3 6-22-82 4 7-14-81 5 5-8-81 6 12-13-79 7 4-10-79		ERASCO SERVICES INCORPORATED DIV. CONTROL DR. RA CH. WALKSINIS DATE MAR. 21, 1978		APPROVED 		NUCLEAR SAFETY RELATED WPPSS QUALITY CLASS I WASHINGTON PUBLIC POWER SUPPLY SYSTEM NUCLEAR PROJECTS NO. 3 & 5 CONTROL WIRING DIAGRAM MECH PENETRATION AREA UNIT COOLER		WPPSS-3240 D-6001 PNL 501	
---	--	---	--	--------------	--	--	--	---	--

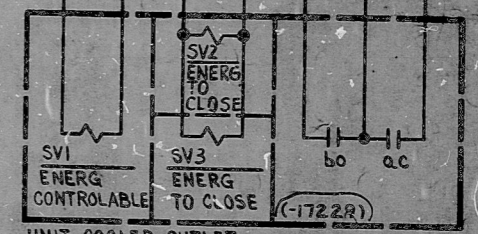
NOTE
1. FIELD TO REVISE LED ENGRAVING TO READ UC7A/7A
2. JUMPER BY FIELD REAPER CARD
